LUMINARY Memo #167 Revision 1

To: Distribution
From: B. McCoy, P. Rye
Date: 17 September 1970
Subject: Luminary 1D: Which One, What Kind, How Many?

Luminary 1D will be released for the third time on 19 September 1970; its revision # is 178. The new changes incorporated are PCRs 322, 1056 and 1058. Herewith are the descriptions.

R10 COMPUTATIONS in SERVICER

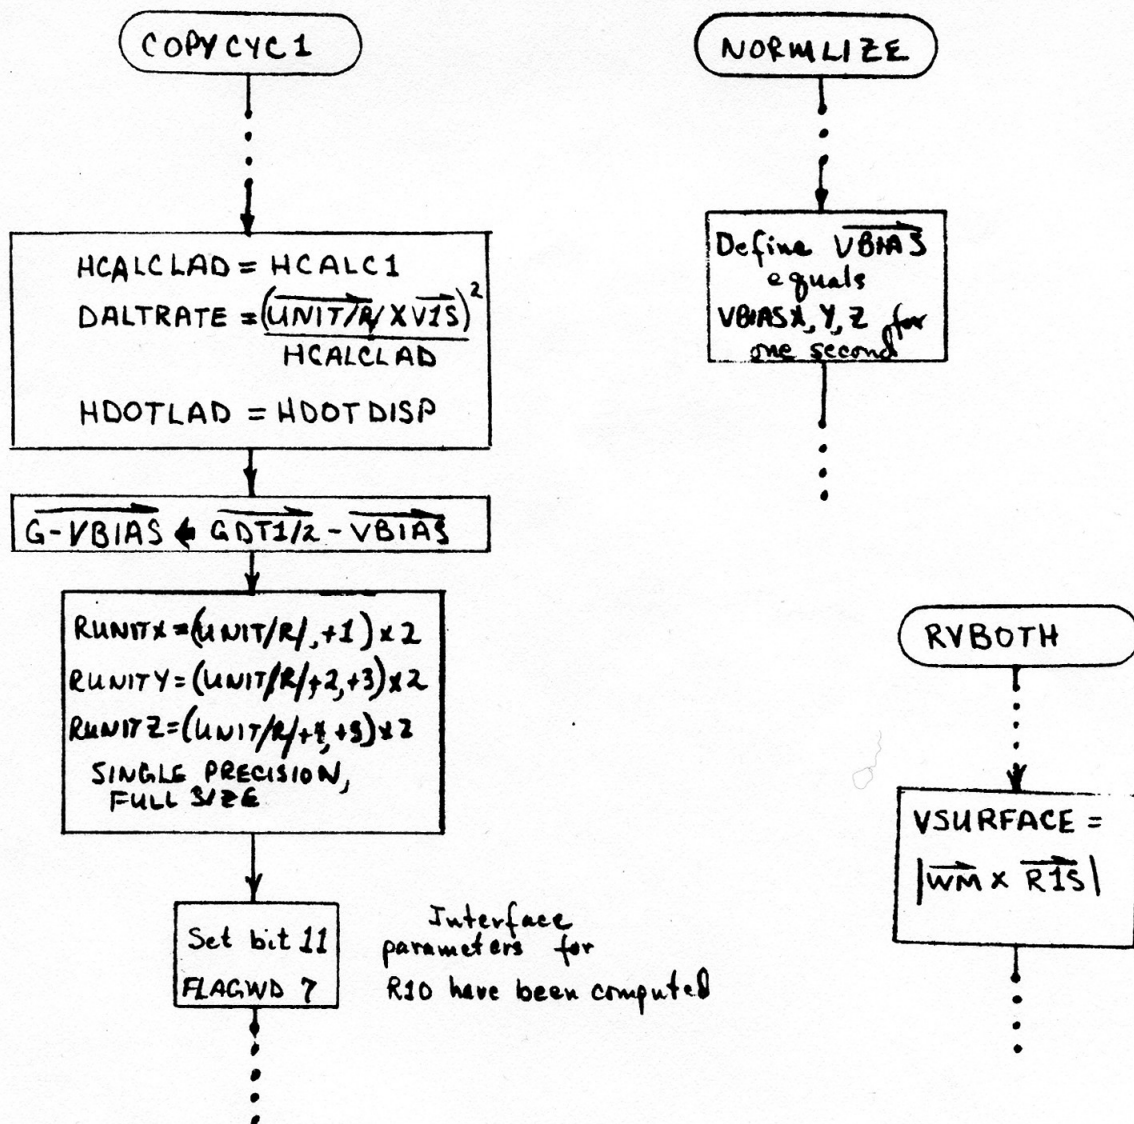
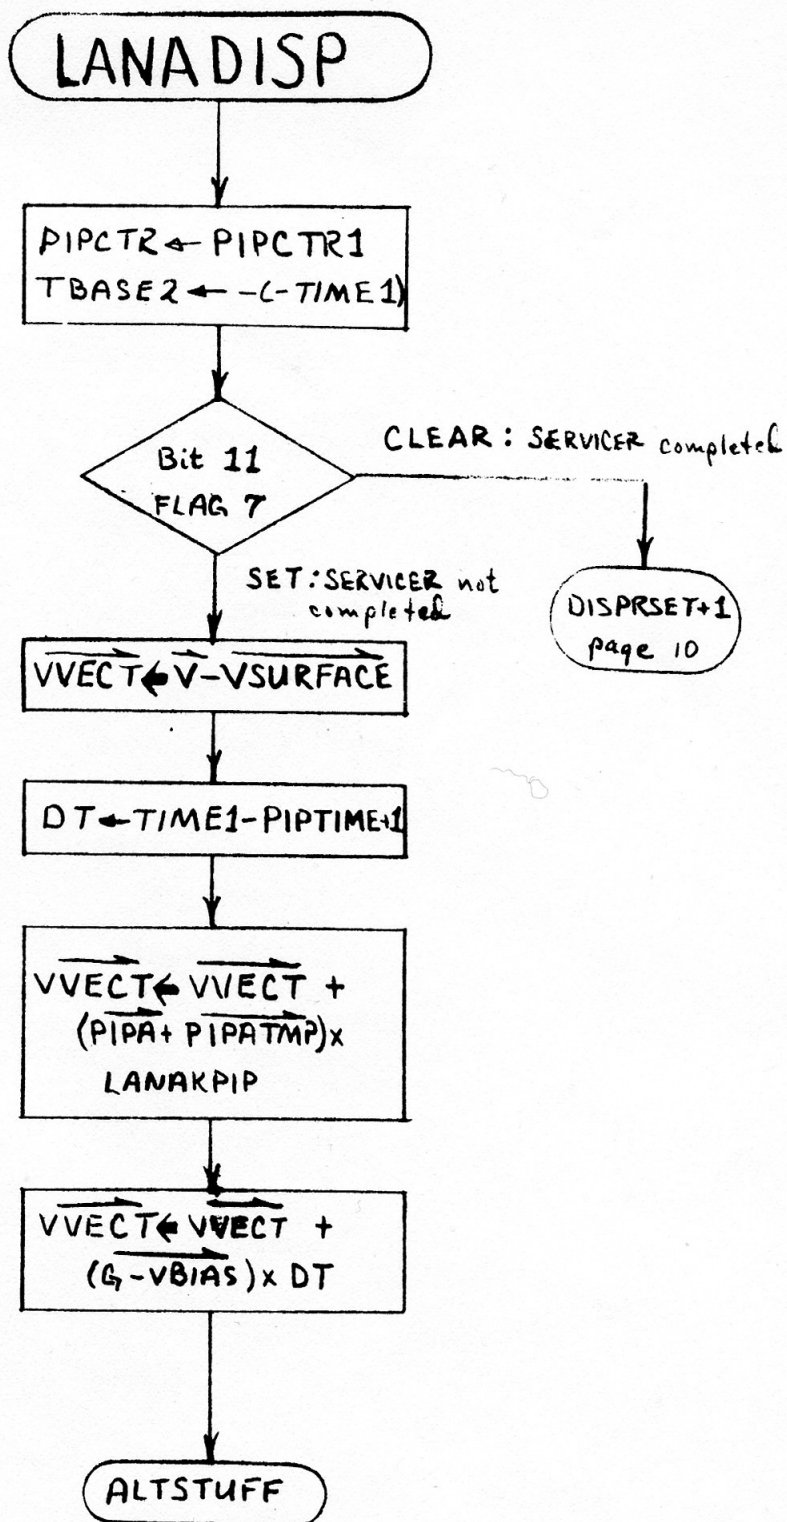
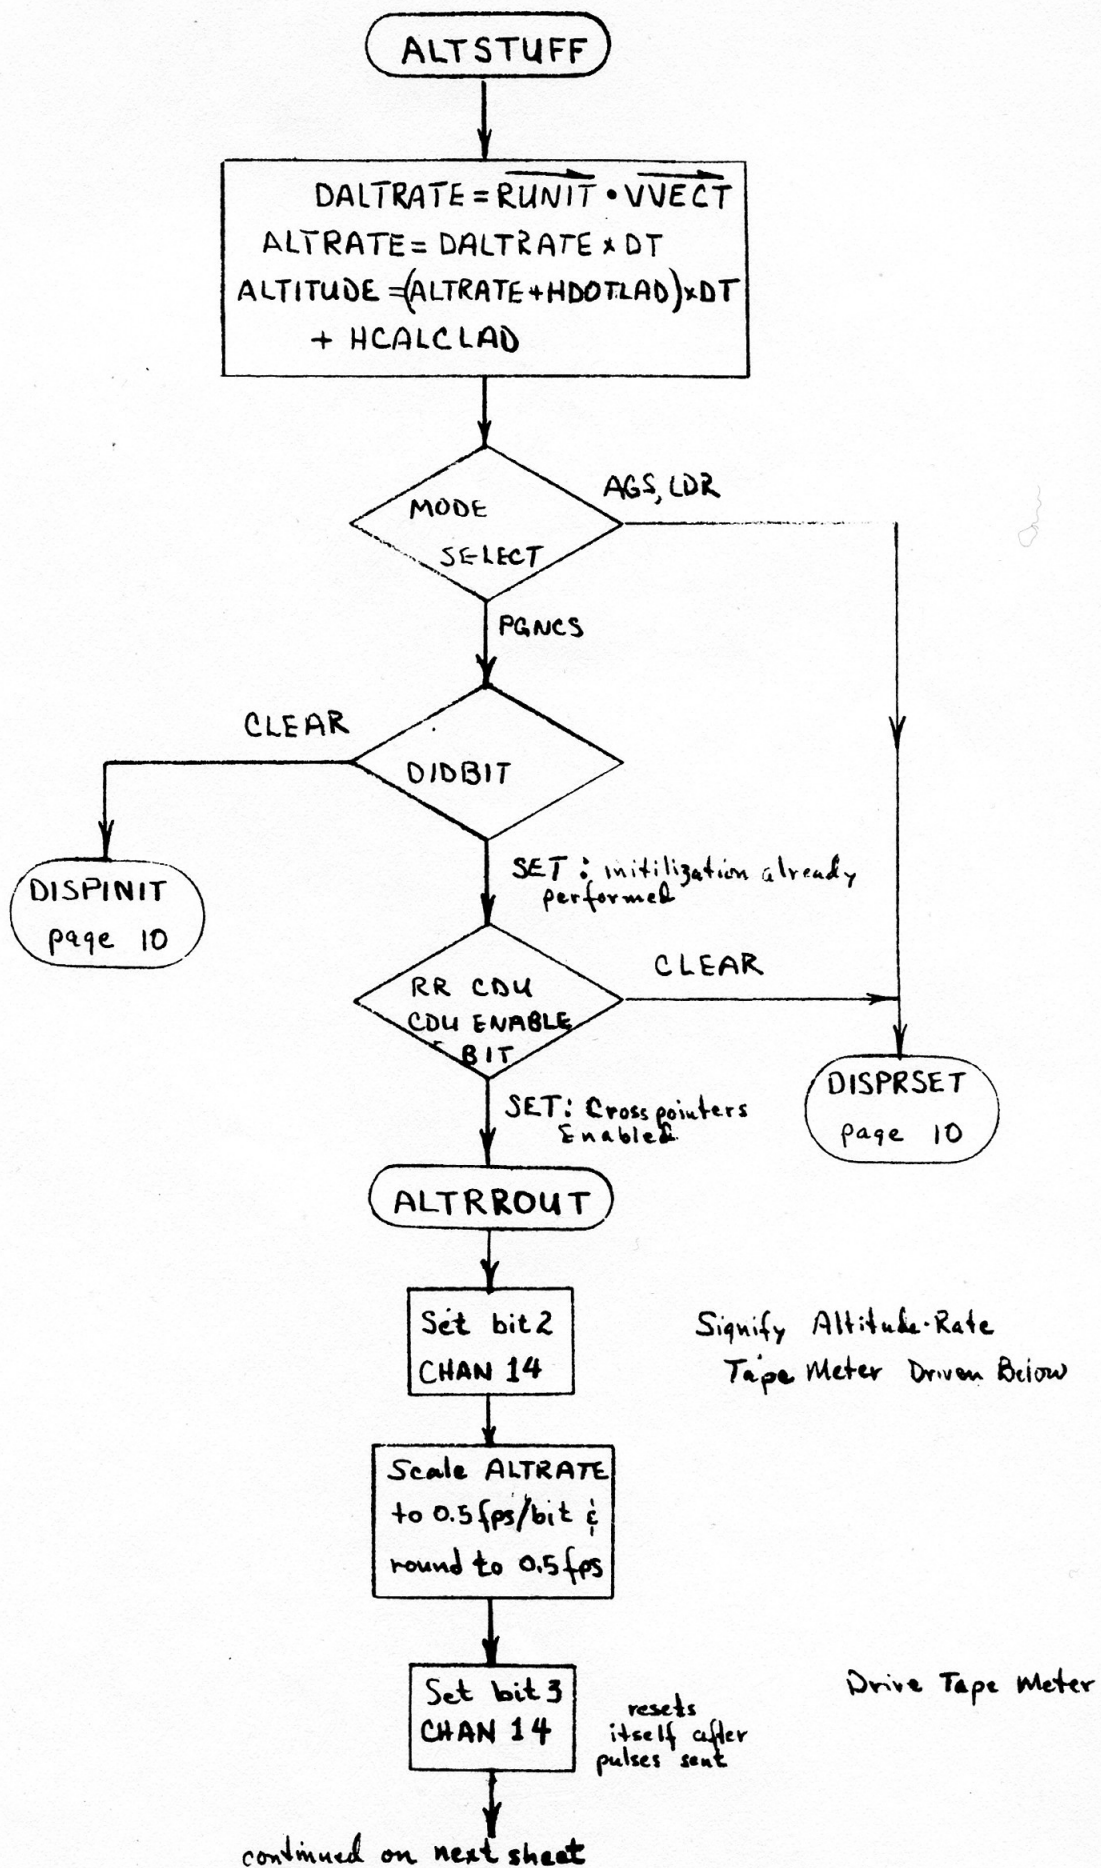
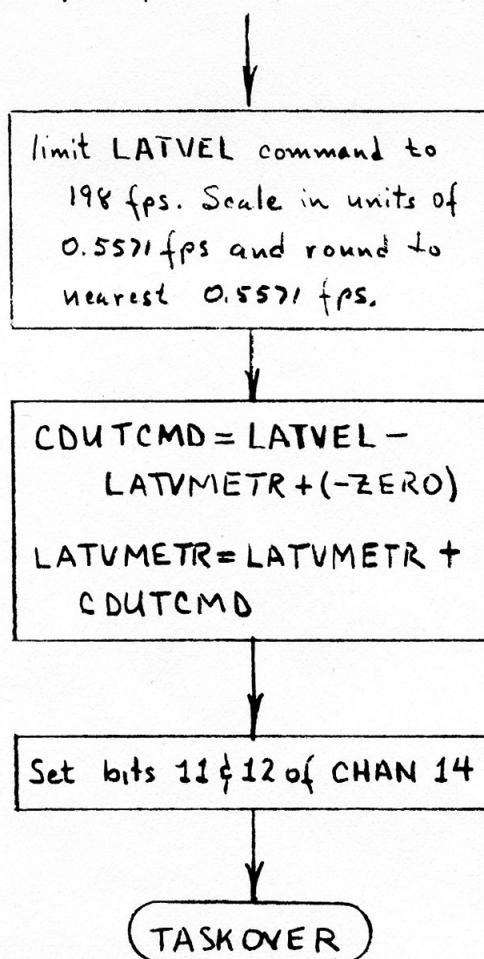
PCR 1058: When it was found that the Landing Analog Displays Routine (R10) gave results with errors up to 3.5 fps in the cross pointer display, a new R10 was suggested to effectively eliminate these errors. In the process the altitude-rate glitch was eliminated. The word saving was 119 words; the new R10 takes 1% longer. The main cause of the errors was the single precision dot products; these were changed to double precision. Also, some computational simplifications were made to the dot products, knowing that the IMU is aligned to the landing site. A PIPA bias correction term is added to increase accuracy; computation of VBIAS formerly done in P66 is now done in SERVICER. Altitude is based on a simpler extrapolation than before. R10 now computes altitude and Alt-Rate every pass (every 1/4 second) outputting Alt-Rate before a 12 cs pause, Altitude immediately after the pause. Flag bit SWANDISP is now set immediately after SERVICER computes the parameters necessary for R10 so that R10 may start near TIG -30 rather than at ignition. The DIDFLAG definition remains the same; just DID the initialization. IMODES33 bit 7 is no longer used. ACB L-11 and Anomaly L-1B-04 were not incorporated into the new R10 as originally conceived, but they are in Luminary 178: The forward velocity for NOUN 60 will be computed if the MODE SELECT switch is not in PGNCS (and incidentally accurate to 0.1 fps); R10 will be initialized if the RR CDU ENABLE bit is removed by e. g. moving the RR MODE switch into and out of LGC.

The R10FLAG has been redefined. When it's set by P12, P70, P71, the inertial Y velocity will be displayed on the lateral velocity cross pointer while the forward velocity crosspointer is set to be zero.

Changes to other areas due to R10 design:

1. downlist mnemonics changes
LATVEL to LATVMETR
FORVEL to FORVMETR
2. VBIAS calculation moved from STRTP66A into NORMLZE;
3. For erasable overlay purposes ZAXIS computation moved to Ascent Guidance from P12 initialization.
4. The erasable ACSAVE, used in ascent, was moved to avoid conflict with the new configuration of R10 erasables.
5. New scaling was implemented to accommodate the double precision value used in R1 of Noun 60.

Flow Charts for R10 and its interface parameter computation are attached. For more details see Luminary Memo #162 by Don Eyles. This memo superceeds Memo #162 where differences occur.
